**RE: Mirabal Residence, 6216 Camino Alto NW
Grading and Drainage Plan
Engineers Stamp Date 6/6/14 (D10D003B1)**

**RE: Drainage Resubmittal
Mirabal Residence
D10-D003B1
Lot 15, Block 6, Unit 22 Volcano Cliffs**

RE: **Mirabal Residence**
Grading and Drainage Plan
Engineers Stamp Date 5/08/14 (D10-D003B1)

Narrative

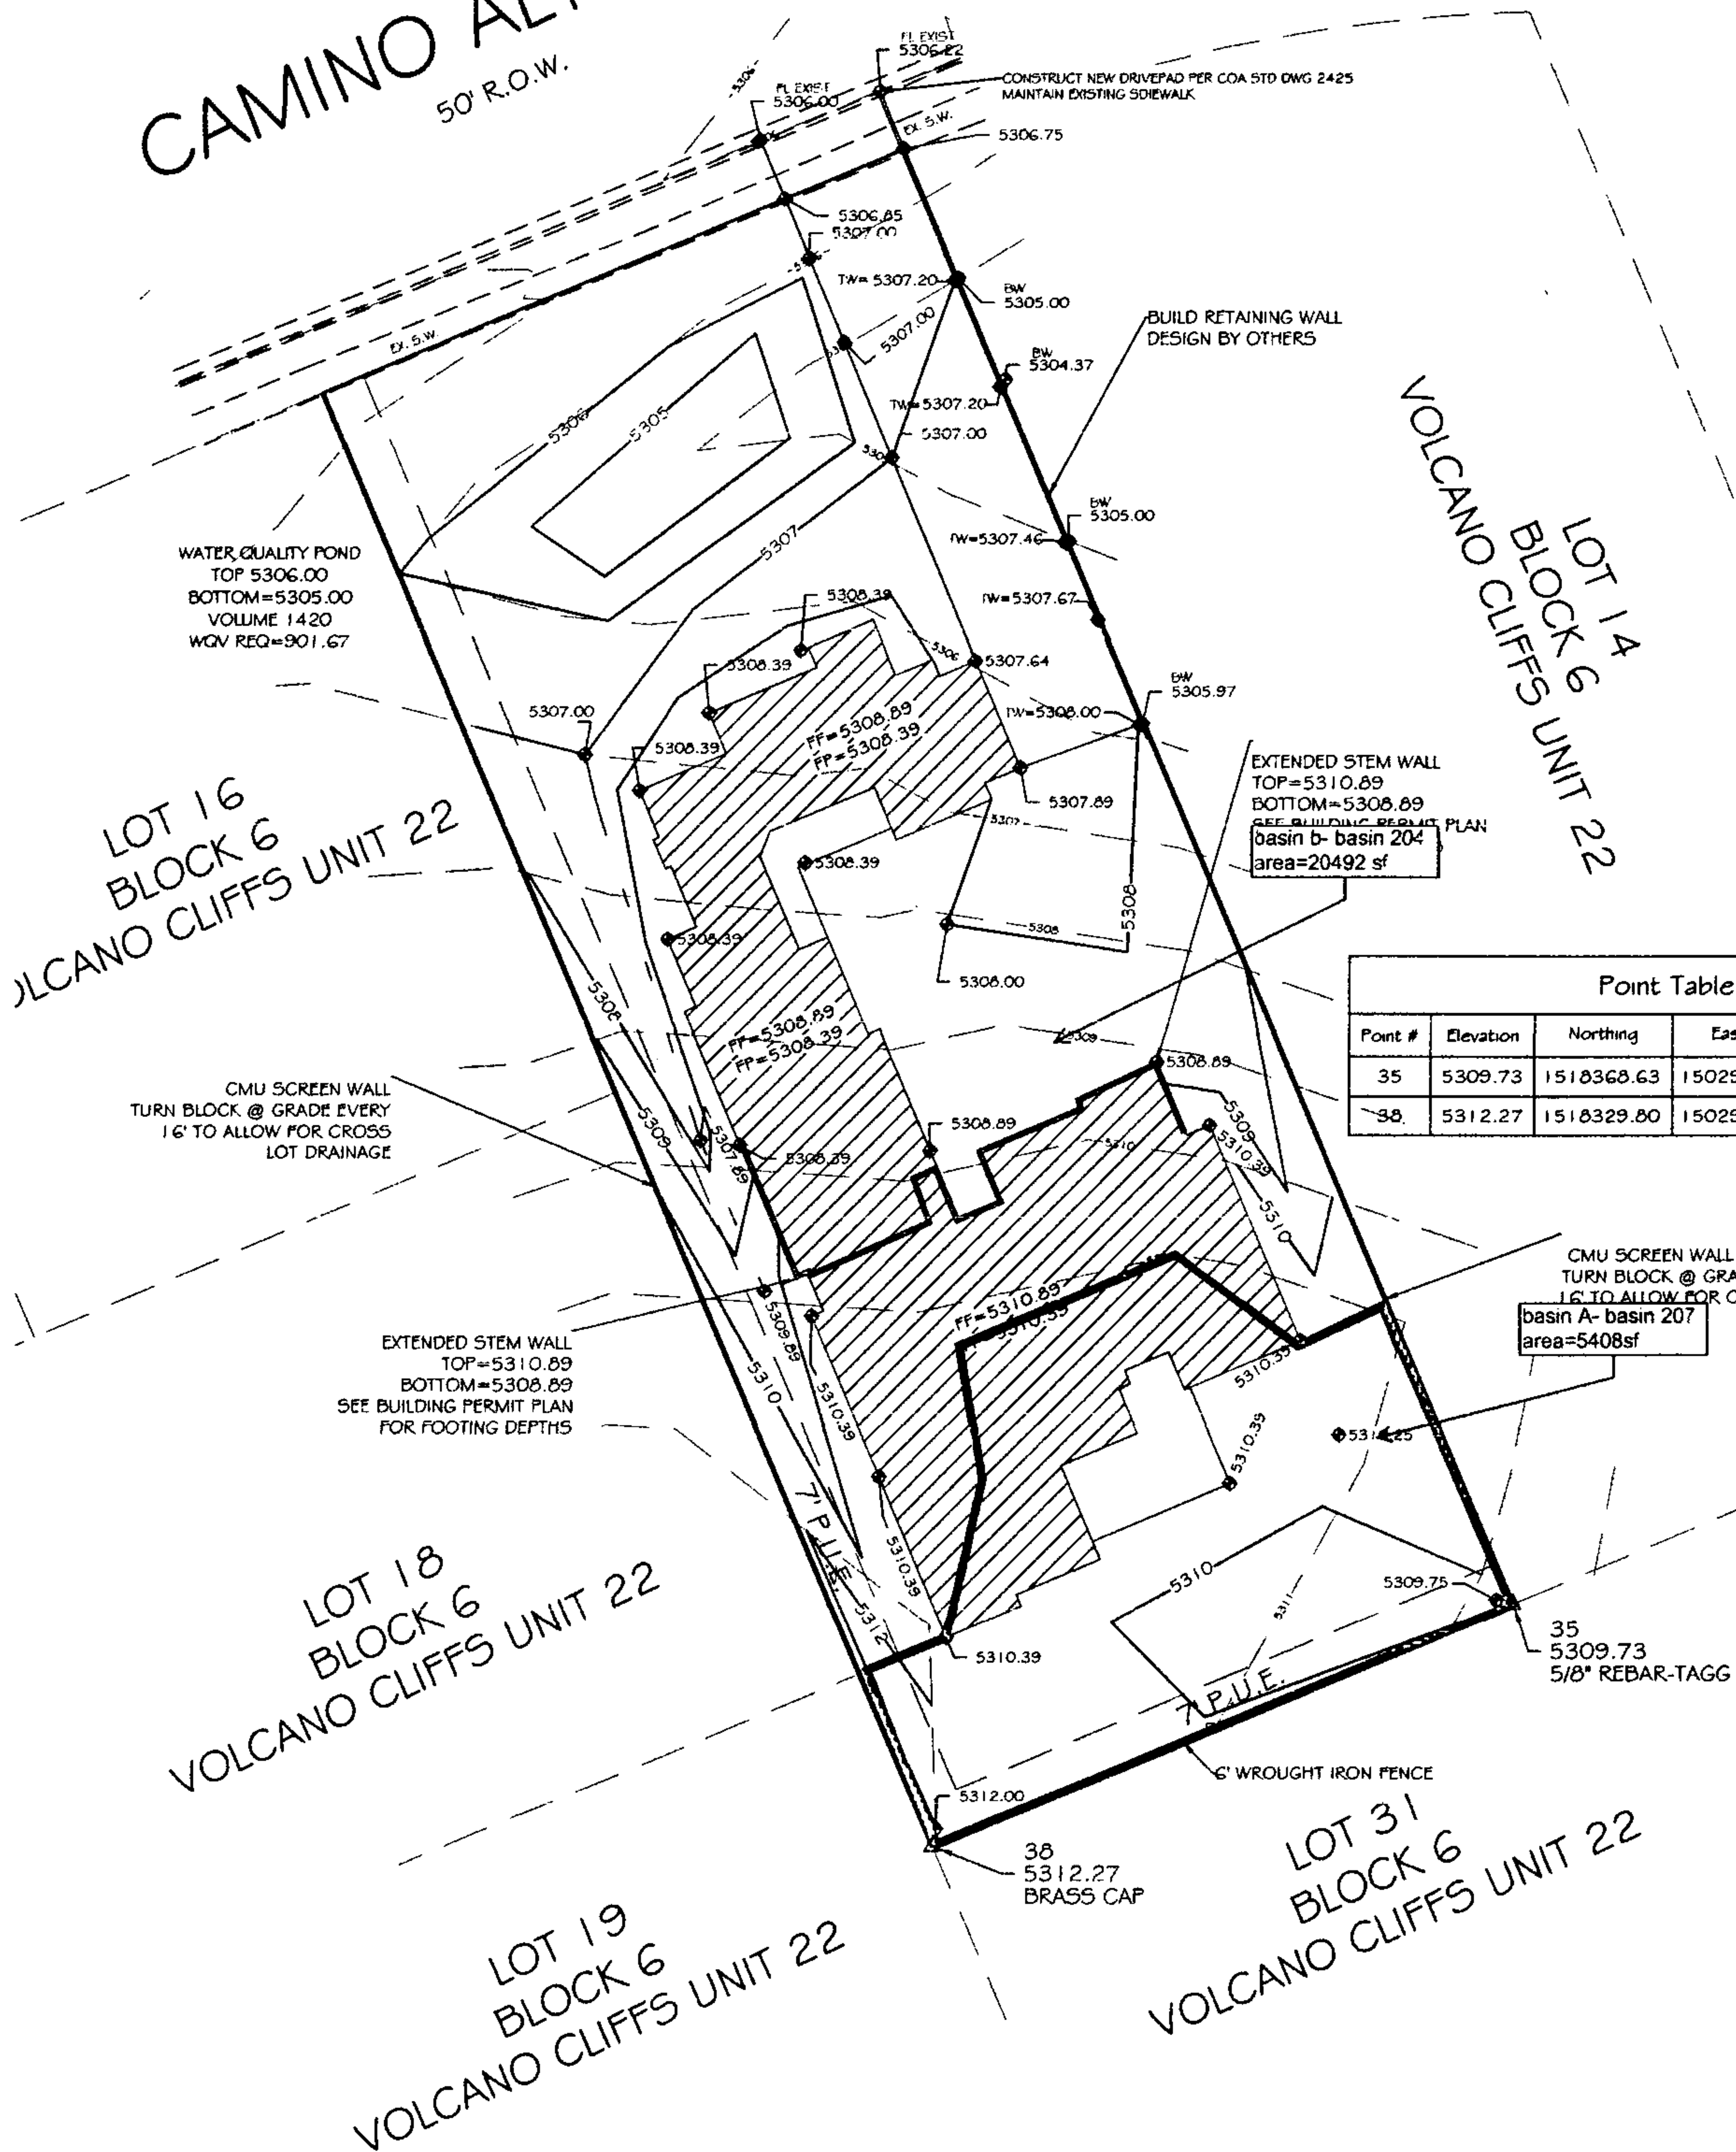
- The ponds and infrastructure need to be certified.
- There is one lot specified on the plans but four addresses given on the sheet. Is this lot being built for 4 homes? ✓
- Build notes are needed. ✓
- Label the proposed contours and differentiate between each contour in the legend. ✓
- This lot is in two different basins. Quantify these flows for pond 7 since Basin 207 is allowed to free flow south. ✓
- How is the remainder of basin 207, to the east of this lot, allowed to discharge? It appears that basin 207 will be blocked with the screen wall. ✓
- The solid black line in the middle of the home, is this a retaining wall? ✓
- Existing contours around the site are difficult to read. ✓
- It appears that flows are headed towards the home in the middle of this site.
- Two elevation spots on the west of the driveway are 5305, they do not appear to be correct?

1. The ponds and infrastructure must be certified.
We do not have control over this comment. The owner is aware and will be dealing with Wilson and Company

2. Address on drainage information sheet is incorrect
We have corrected
3. Build notes are required
We have added
4. label and differential contours
We have added labels and corrected on legend

5. Site has two basin, quantify
The attached spread sheet and exhibit show
6. allow upland basin 207 to enter site
We have provided turned blocks to allow upland flow

7. clarify solid black line interior of house
We have called out the step in slab
8. existing contours difficult to read
We have darken the lines to help
9. correct flow heading towards house near middle
I correctly showed a 2' stem extends past step in house, the provides for flow away from house.

10. elevation of 5305 at west side of driveway appear incorrect
The mislabeled spots were corrected
